ABA Fashions New

20th & 21st May 2018

Observations

Fourth Floor Plan

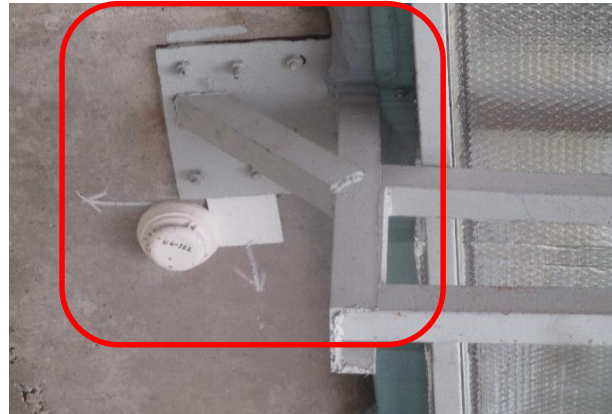
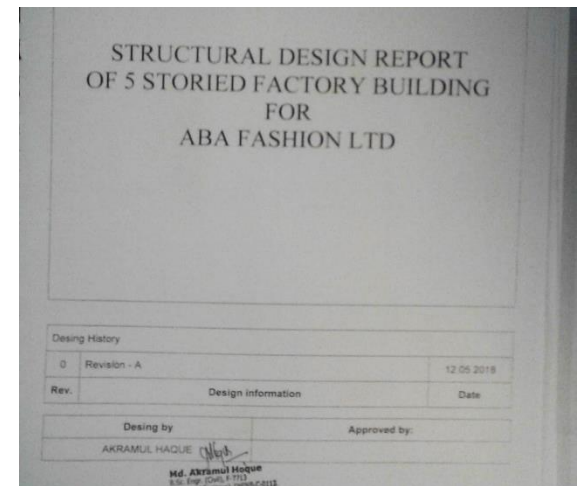
Lack of documents for fourth floor canopy

No drawings and connection details were found for canopy over the building at 4th floor. Factory engineer is required to prepare as contracted drawing with connection details for the canopy.

Item No.	Observation	Recommended Action Plan	Recommended Timeline
1	(RMG Building) Lack of documents for fourth floor canopy	Building Engineer to survey as-built structure and prepare accurate as-built documents for the Canopy.	6-weeks
2	(RMG & Utility Building) Prepared load plan required to be verified	Maintain 3 Kpa load on all floors.	6-weeks
3	(RMG & Utility Building) Prepared load plan required to be verified	Complete the review of design report with Accord.	6-weeks
4	(RMG & Utility Building) Prepared load plan required to be verified	Produce and actively manage a loading plan for all floor plates within the factory giving consideration to floor capacity and column capacity if loading above 3 kpa is considered.	6-weeks
5	(RMG & Utility Building) Prepared load plan required to be verified	Complete remedial works arising from design report after reviewed by Accord.	6-months
6	(RMG & Utility Building) Prepared load plan required to be verified	Continue to implement load plan.	6-months

Design Report

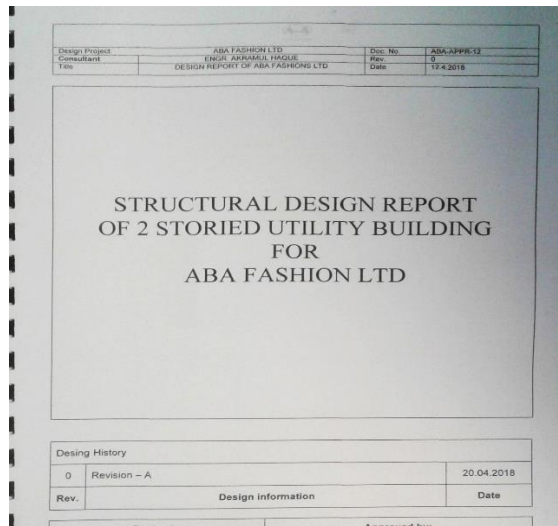
**Prepared load plan & design report plan
required to be verified**

Floor loading

Factory engineer has prepared a design report and load plan considering 8 kPa maximum allowable floor loading for the RMG building. Which need to be reviewed by Accord.

Factory is required to maintain the floor live load 3 kpa until verification of prepared floor load plan.

During inspection no over loading was found. FOS calculation for internal & external columns were found satisfactory considering 3 kpa allowable floor live loading.
